APPLICATION FOR PERMISSION
A/YL-TYST/1146 UNDER SECTION 16 OF
THE TOWN PLANNING ORDINANCE
(CAP.131)

Proposed Service Reservoirs

**Planning Submission of Service
Reservoirs**

HSK Pk B: Update on Planning Application No. A/YL-TYST/1146

FIGURE 5a

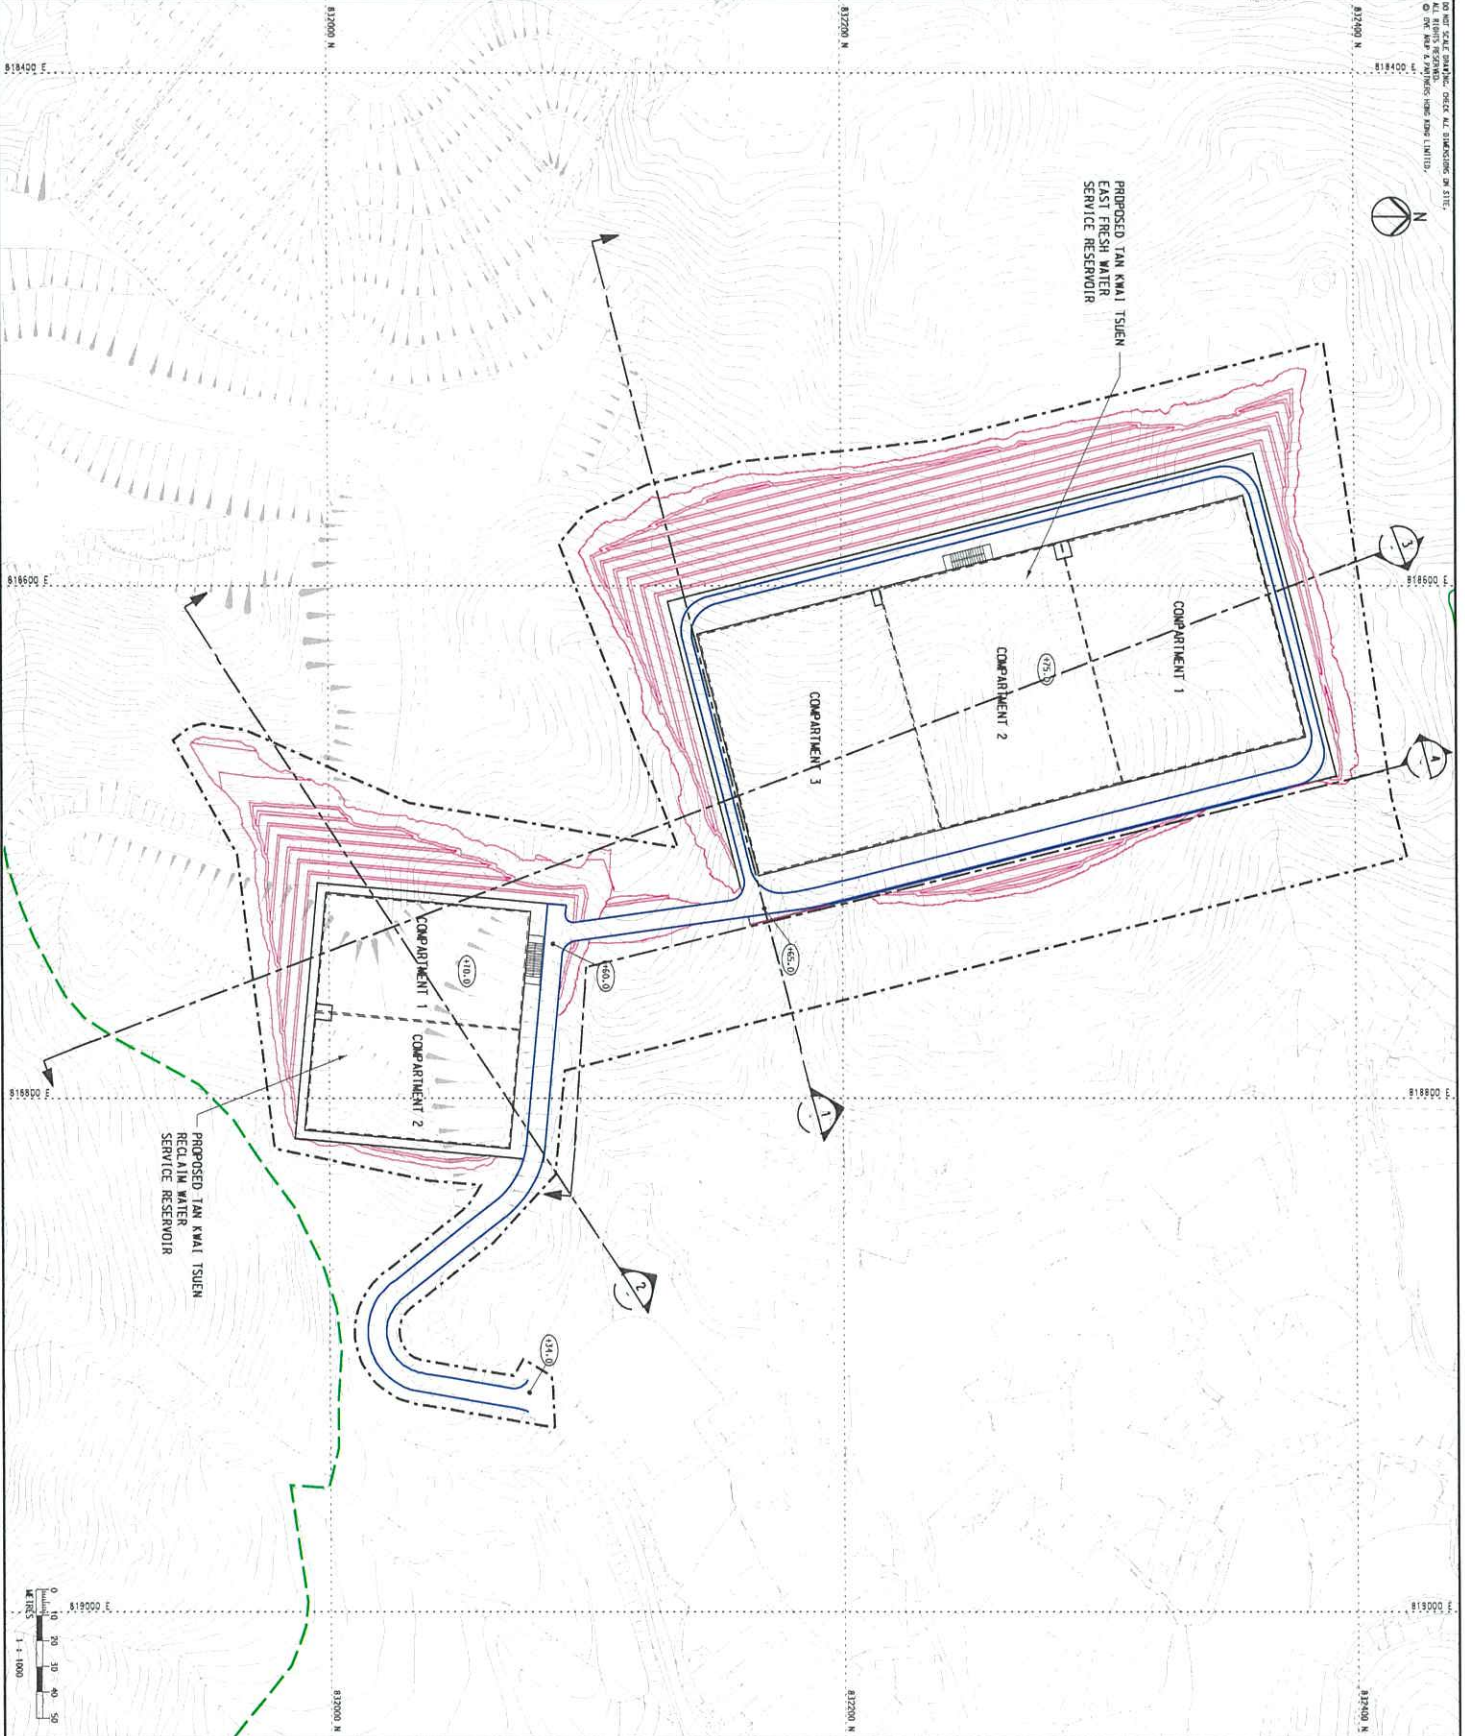
- 1) 請提供于圖紙（編號：FIGURE 5a）上注示的Section 4 的圖紙供參考。
- 2) 公示文件上的視覺點（Viewpoint）過於片面，此配水庫勢必影響唐人新村西向的景觀，且破壞當地原住民喪葬位置。
- 3) 修建大型配水庫會影響當地環境。

Figure 1 – Application Site of the Proposed Service Reservoirs and the Concerned Two Private Lots

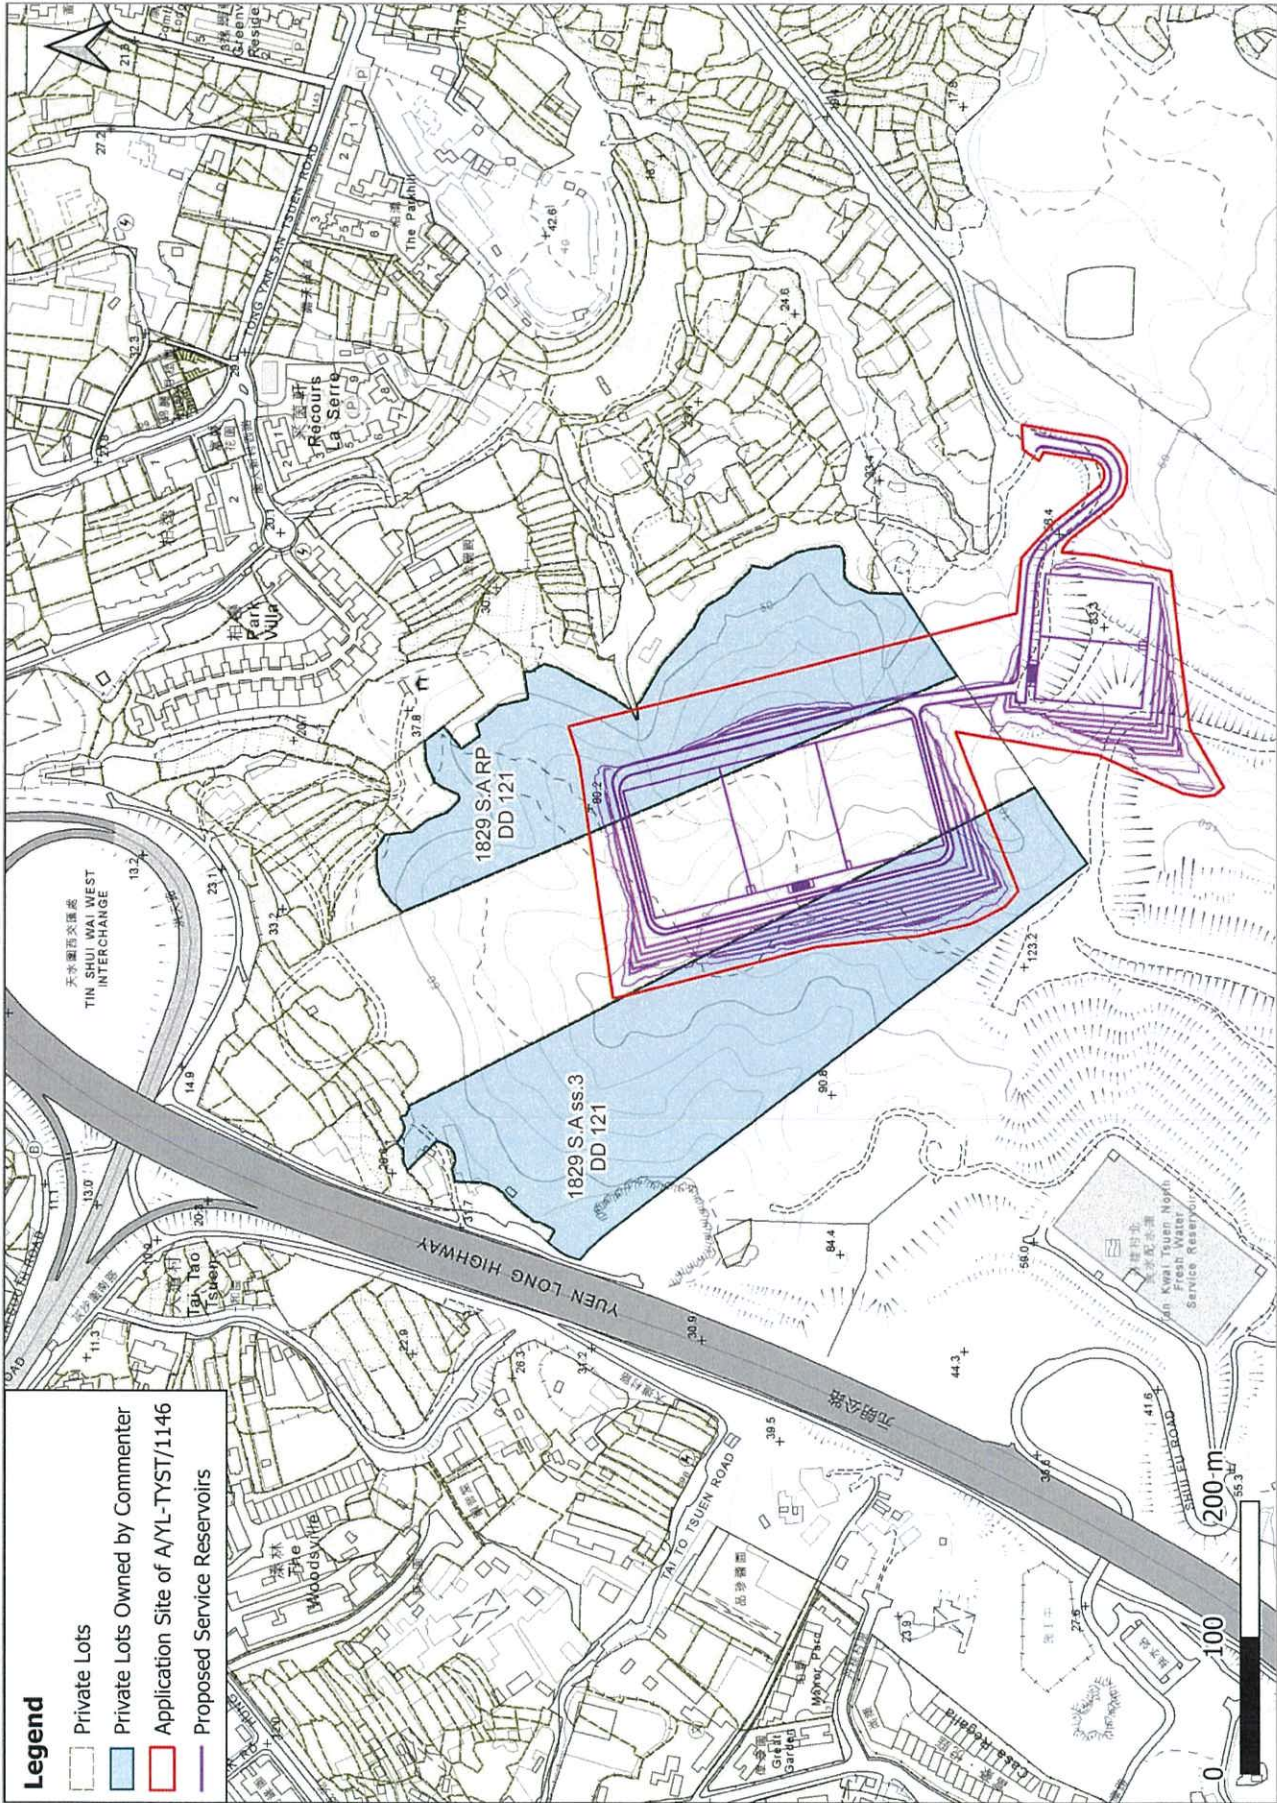
- (1) The application, if approved, will require resumption of major portions of the 2 mentioned private lots (i.e. Lot A and Lot B). As illustrated in the enclosed **Figure 1**, more than one-third of Lot A and about 20% of Lot B will be resumed for the subject proposal.
- (2) Lot A would be bisected into 2 isolated portions and leaving the northern portion inaccessible. We therefore earnestly request Town Planning Board, in giving its approval, to impose conditions requiring CEDD to provide access (and/ or maintain existing access) of the northern portion of Lot A through the southern portion.
- (3) In view of large-scale slope cutting, we would like to request further information (including detailed drawings) of the proposed service reservoirs for our assessment of the impacts thereby to the geotechnical stability of our Lot A and Lot B.
